# Donald C. Cook Nuclear Plant Units 1 and 2 ANNUAL ENVIRONMENTAL OPERATING REPORT

ATTACHMENT TO C0401-10  
ANNUAL ENVIRONMENTAL OPERATING REPORT

## **Annual Environmental Operating Report**

**ATTACHMENT A**  
**SGRP ENVIRONMENTAL REVIEWS**

99-042

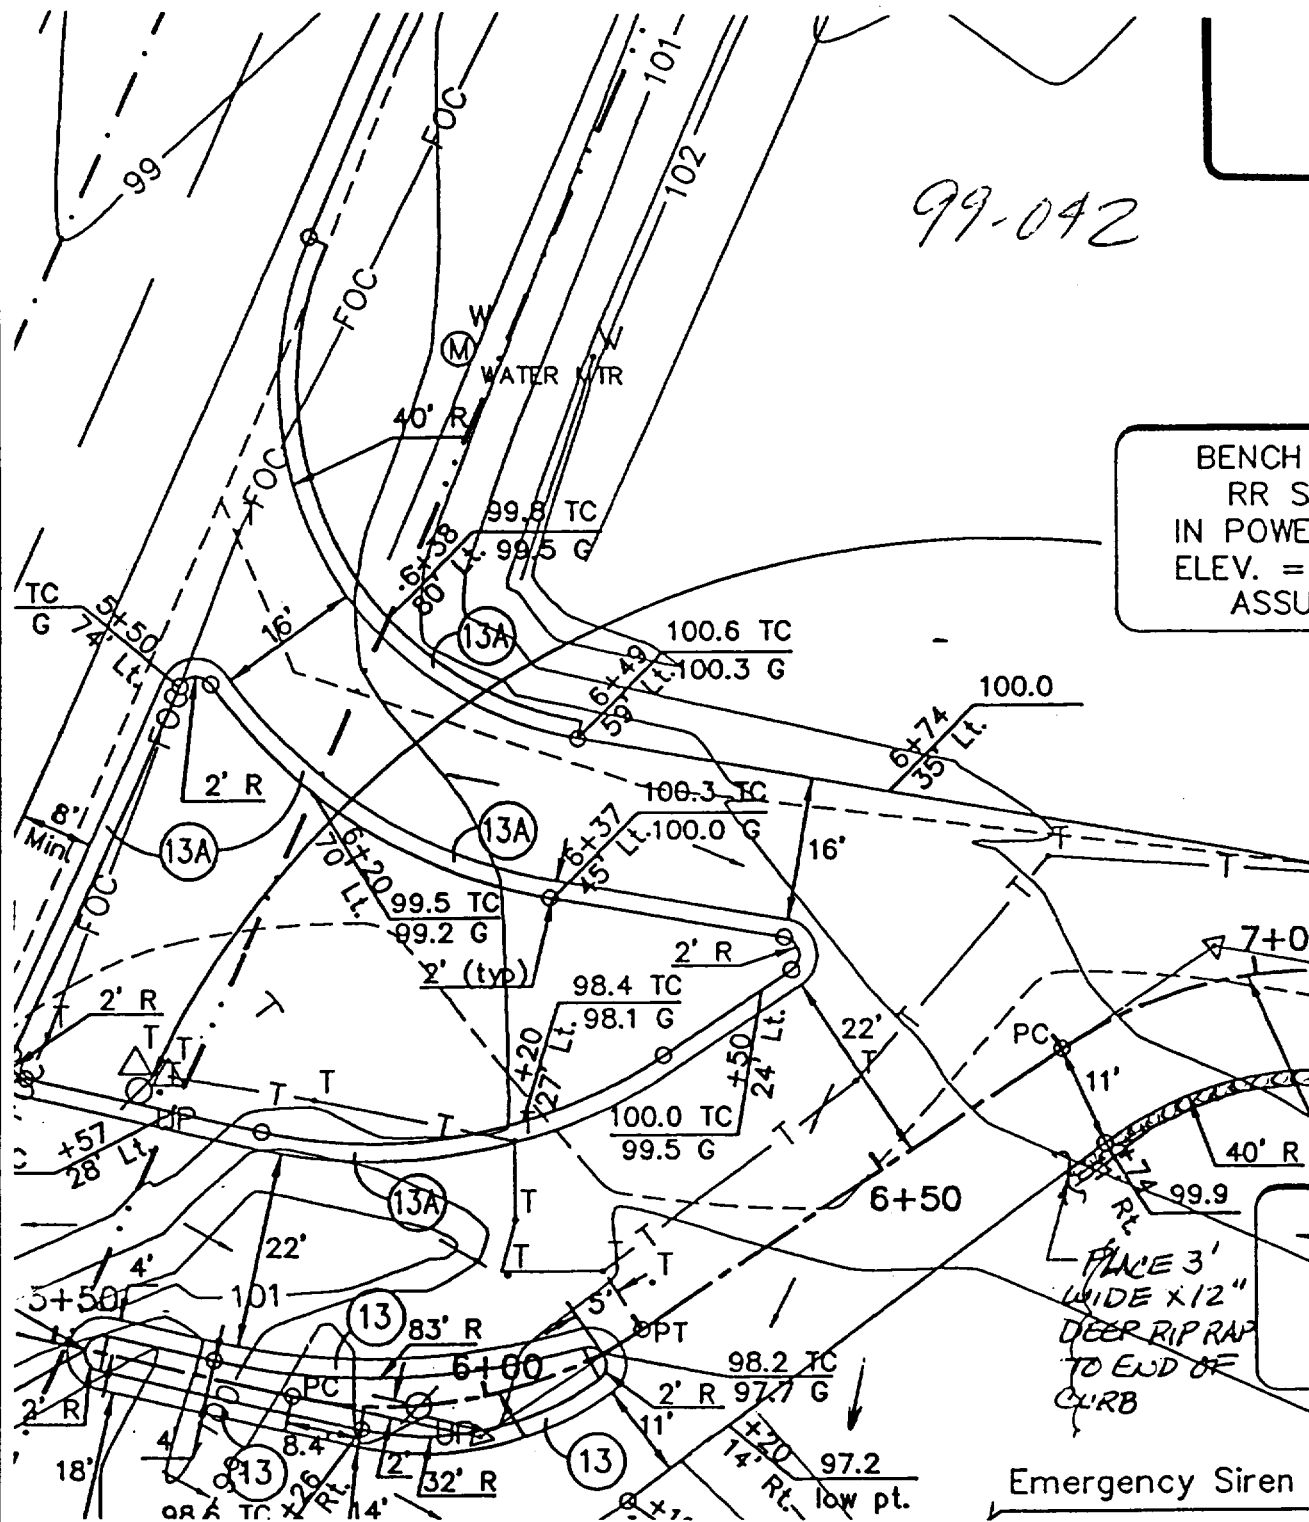
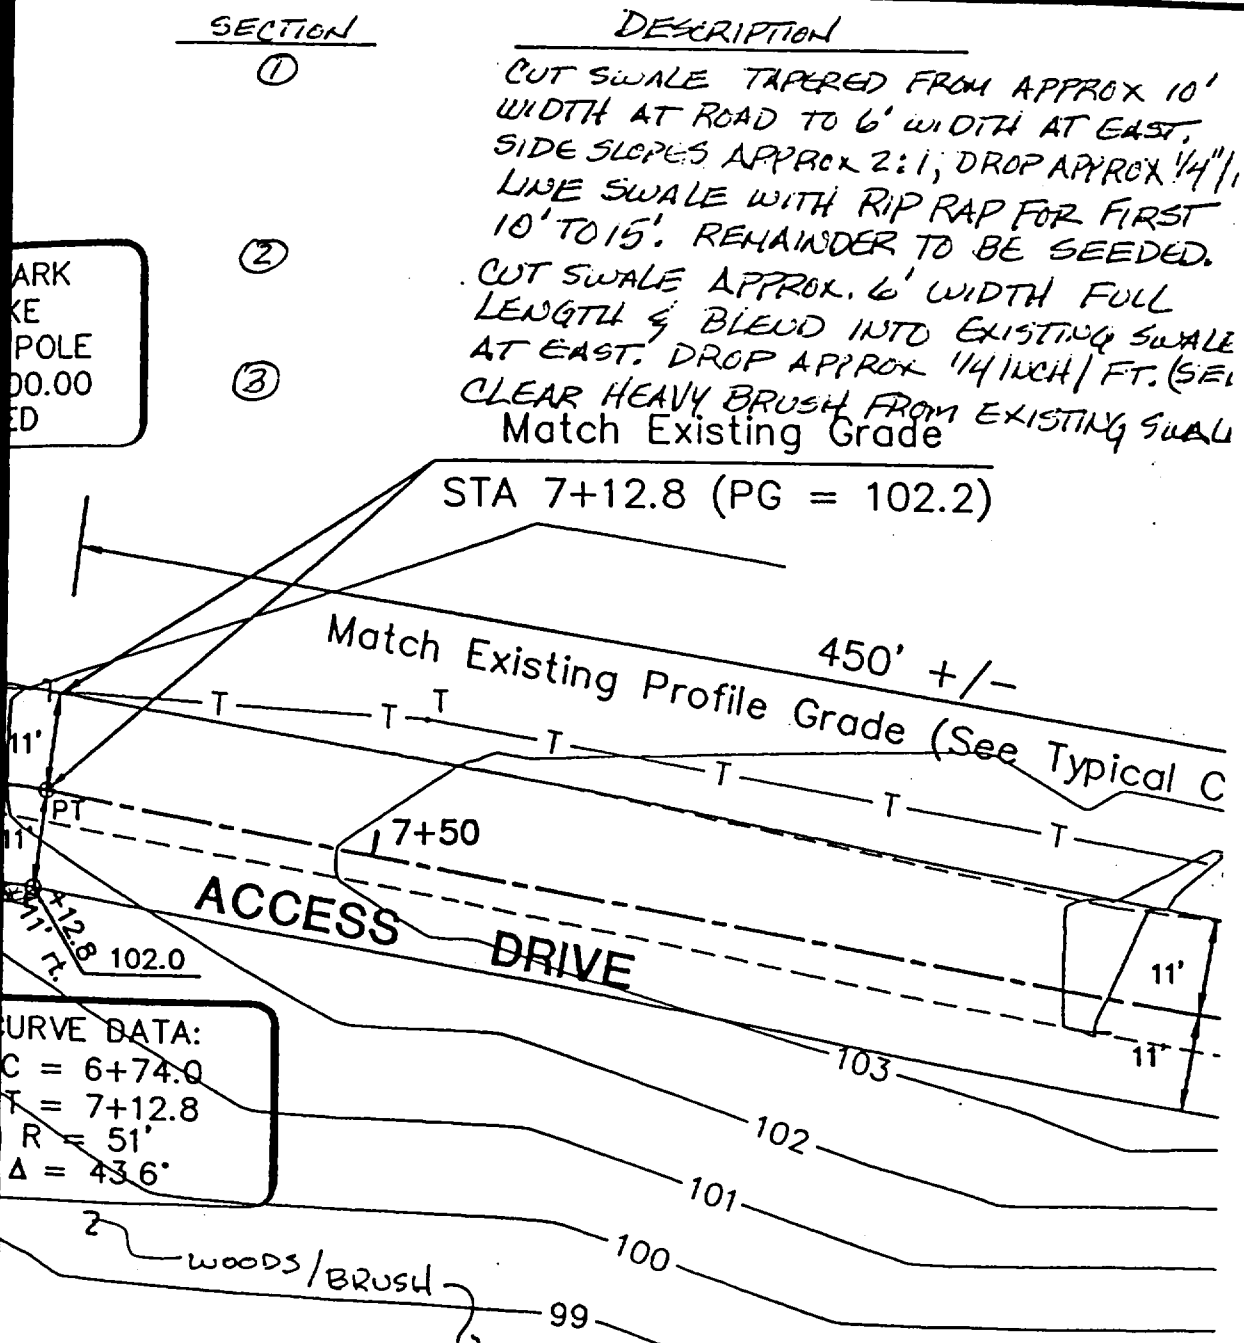
Ensure stumps + mulching are done promptly to avoid erosion of the swale.

Senay Melby agrees with the attached plans - (MDEQ storm water).  
Include the changes in the SUP3 Annual review.  
The area will also need to be inspected semi-annually.

99-043

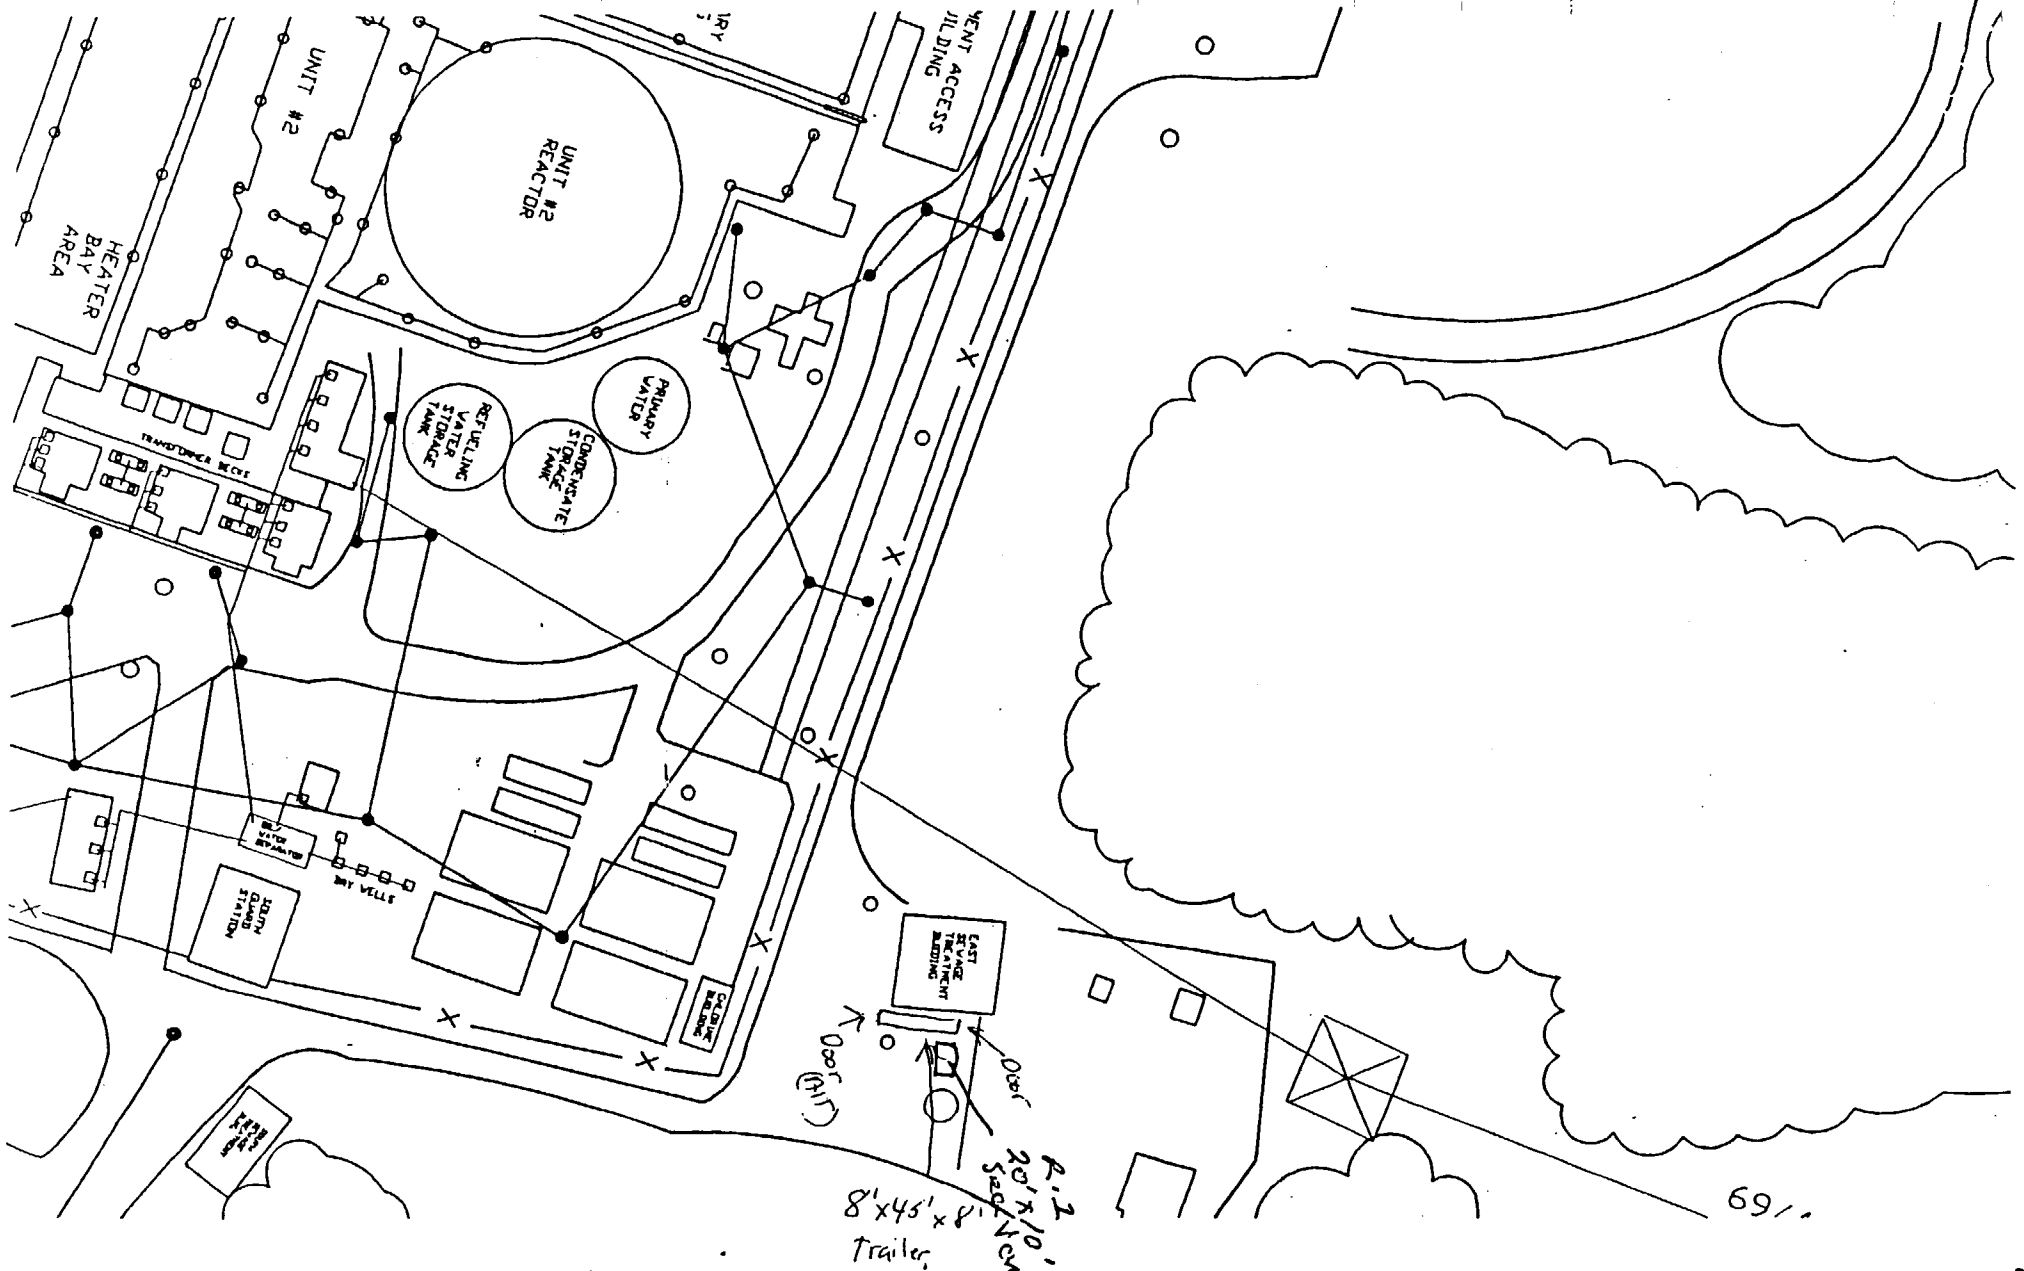
Chemical storage permit per PMI-2160 is required  
if chemicals will be stored in the trailer. B. Helly 9-28-99

No Digging - No Bulk Liquids therefore No Dunes Permit or B.C. erosion  
required. Enclose trailer - No Stormwater concerns.  
Add a 20' x 10' Sea Van 11-10-99

ATTACHMENT TO DIG PERMIT  
No. 1059  
REV 0 ~~RBB~~ 9/28/99

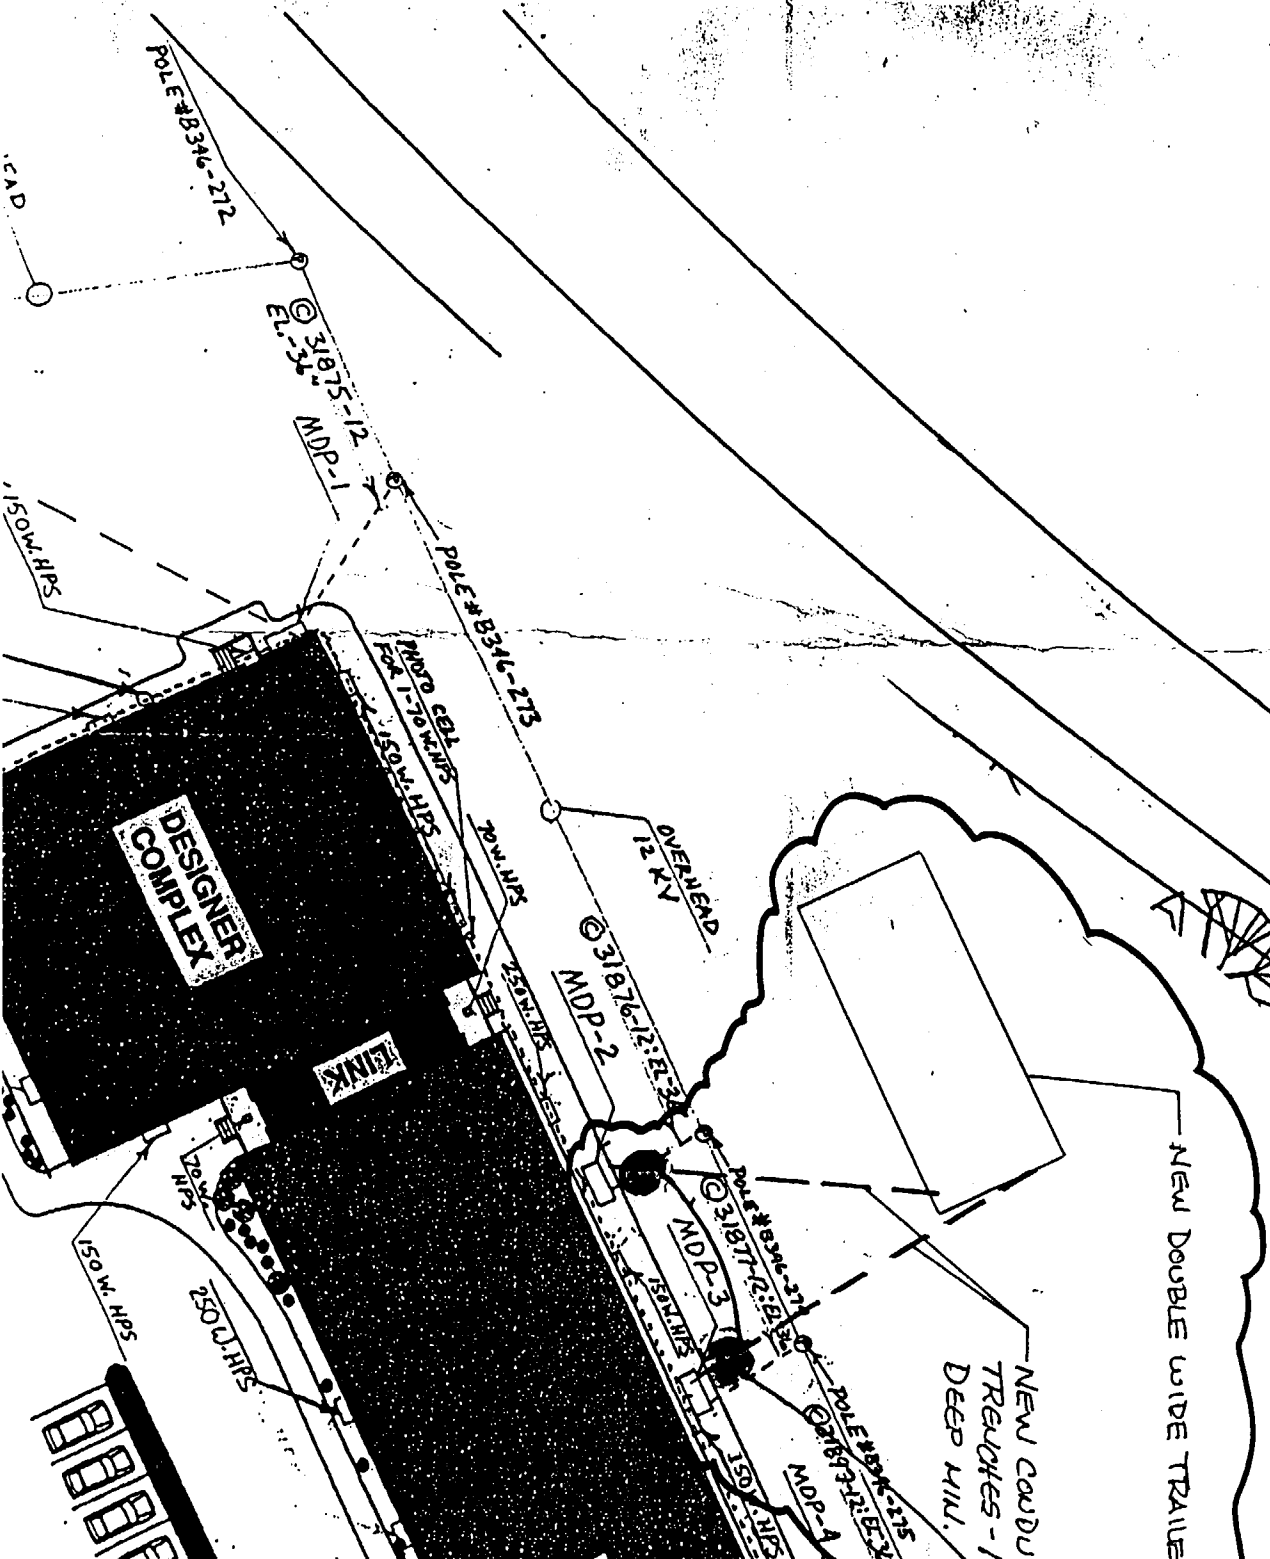
Prevent soil contamination of any stormdrains in  
Plant access Road. Re Use Soil as Fill when  
Trench work is complete

>500 feet from lake Crit Dunes: Exempted in  
Previous Permit for the area since it is  
no where near Dunes
